Re: TEDS Exceptions, 2793 Skyline Court

TEDS EXCEPTIONS 2793 SKYLINE COURT

Re: Design Exception DE# 6-17, 18 & 19

DESIGN EXCEPTION #DE 6-17, 18 &19

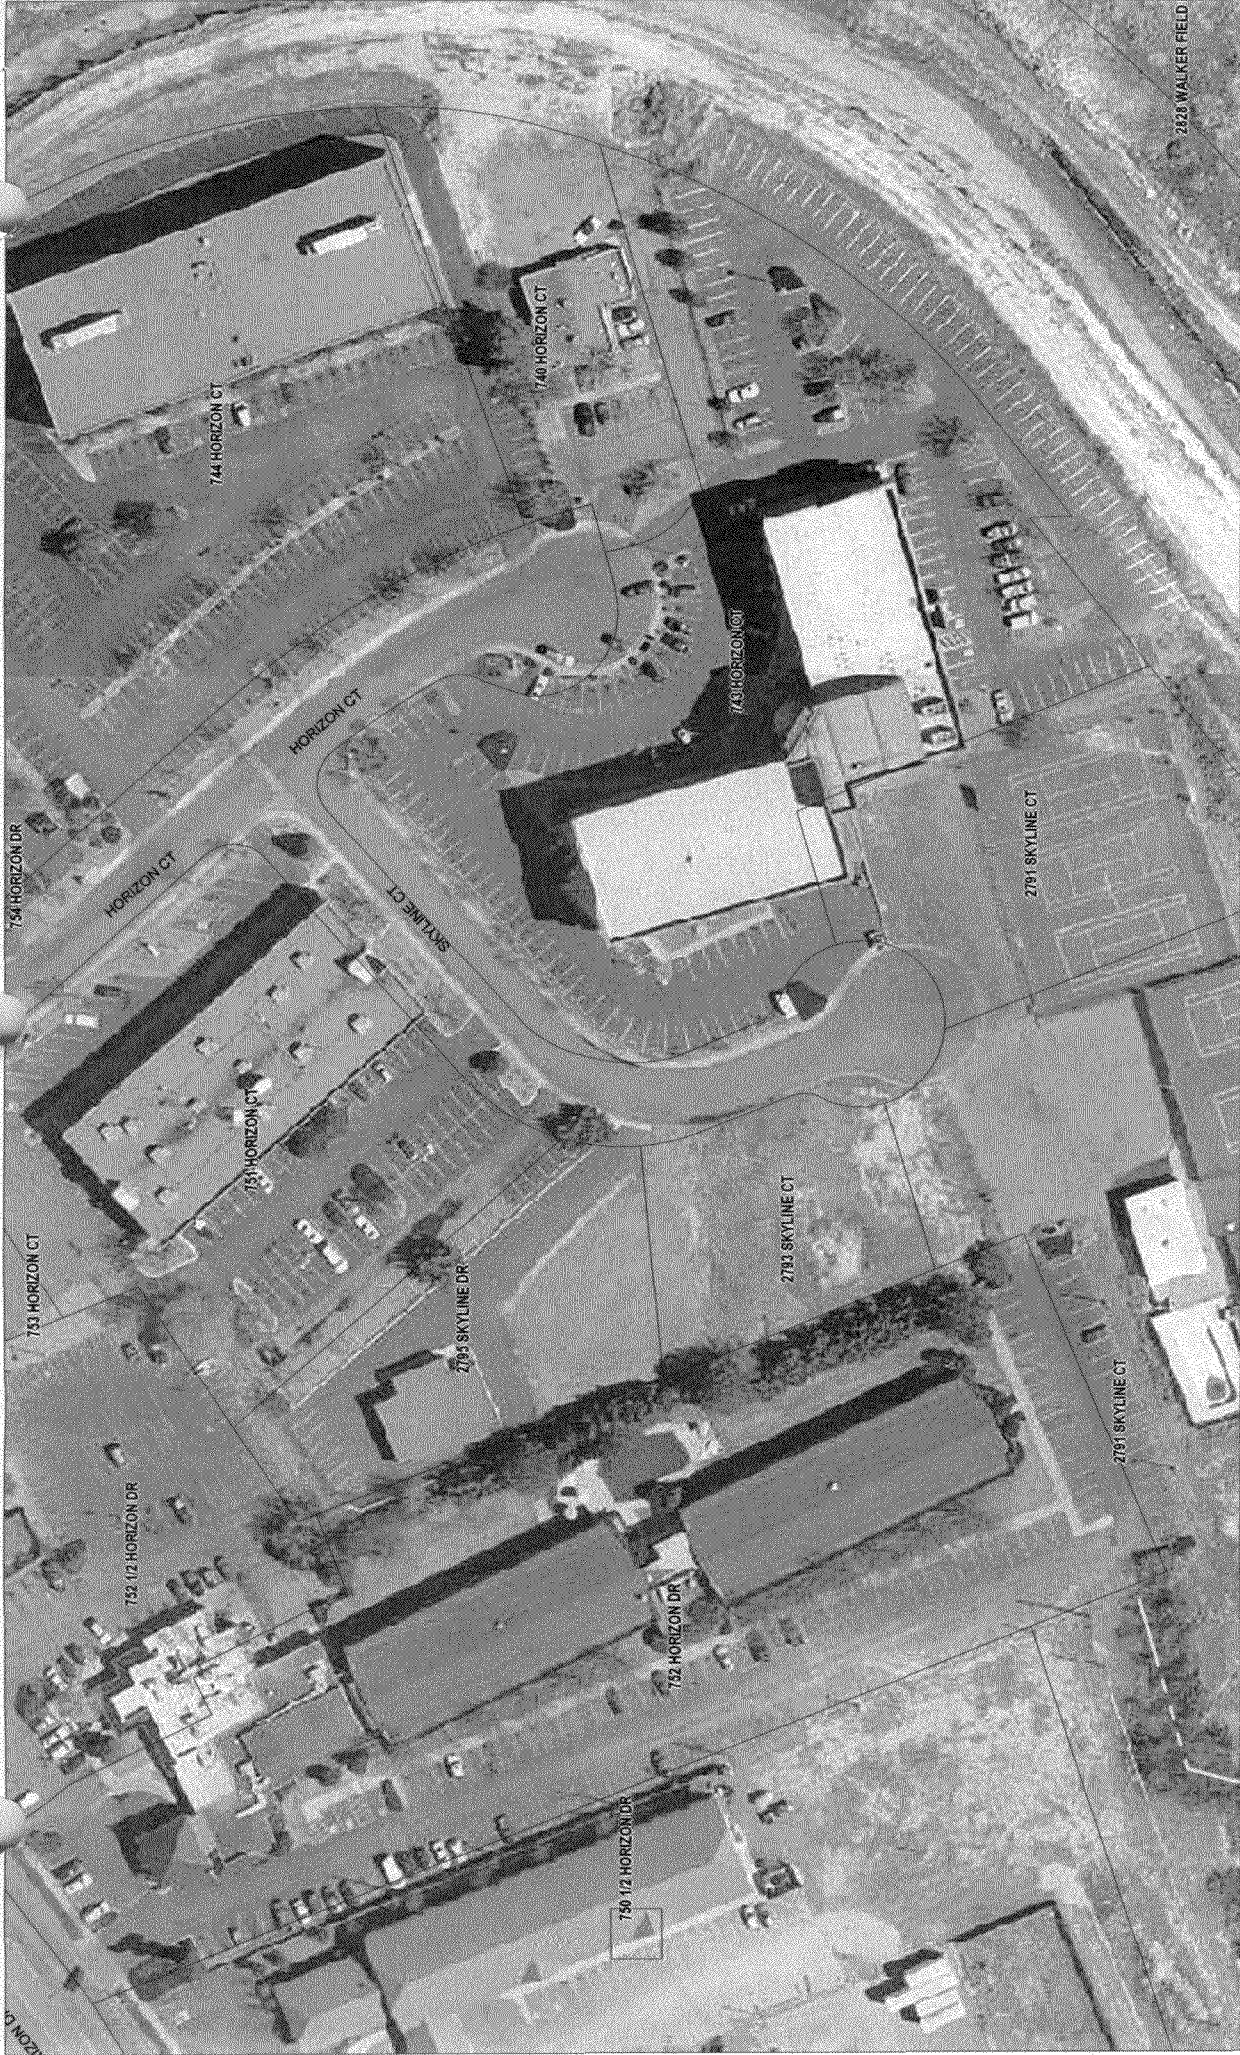
The proposed driveway has 16 feet of separation from the nearest driveway to the south. Section 4.1.1 of TEDS requires a minimum of 50 feet on local commercial streets.

Skyline Court is designated a local commercial street with a right-of way requirement of 52 feet of right-of-way. The existing right-of-way is 50 feet wide.

We are proposing to grant a 12 foot multipurpose easement overlaying the existing 6-foot utility easement.

This request goes hand in hand with the right-of-way request. The distance from the back of sidewalk to the outside of the 12 foot easement (15 feet) will be the same if we do not dedicate the 1 foot and the street is never widened (See section on site plan).

- The City of Grand Junction has allowed less than a 14 foot wide Multi-Purpose easement in locations where there is sufficient room between the adjacent street improvements and the edge of right of way. In this instance, there will be an additional 2 – 3 feet of room between the top back of the new sidewalk and the existing right of way line (refer to attached site plan)

Staff recommends approval of the three requested exceptions. Staff agrees that Skyline Ct. appears to function adequately even though it provides less than the standard pavement width for a Local Commercial roadway when considering the amount of adjacent off-street parking available along Skyline Ct. Commercial roadways typically allow on-street parking which requires additional pavement width.

-Staff agrees that providing a 12 foot wide Multi-Purpose easement, when combined with the additional 2 – 3 feet of width available in the right of way, will provide adequate room for utility providers to place dry utilities when needed in the future.
